[EERE–2021–BT–TP–0019]

Energy Conservation Program: Test Procedure for VRF Multi-Split Systems

ACTION: Final rule.

Figure III-1: DOE's Proposed Enforcement Process from the December 2021 VRF TP NOPR

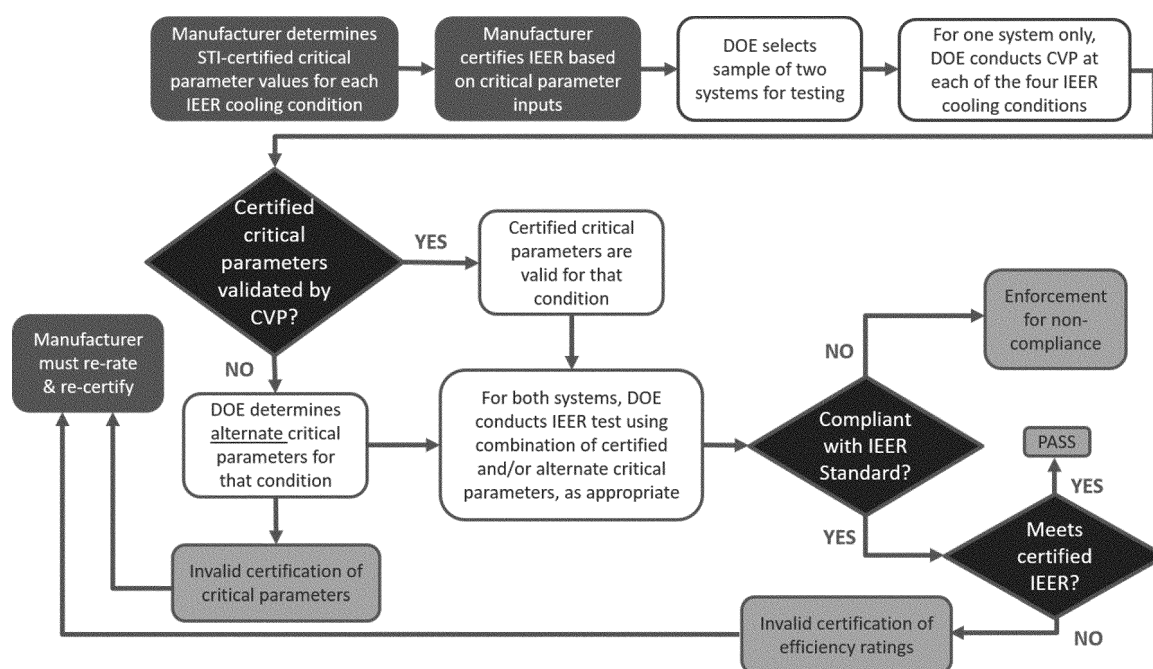
Daikin commented that this figure illustrates that regardless of whether a CVP is performed, the basic model must be re-rated if the IEER testing results are deemed invalid. Daikin asserted that the proposed regulatory text did not indicate that if critical parameters are validated but the IEER is not validated then a re-rate is required, as indicated in the figure. (Daikin, No. 13 at p. 7)
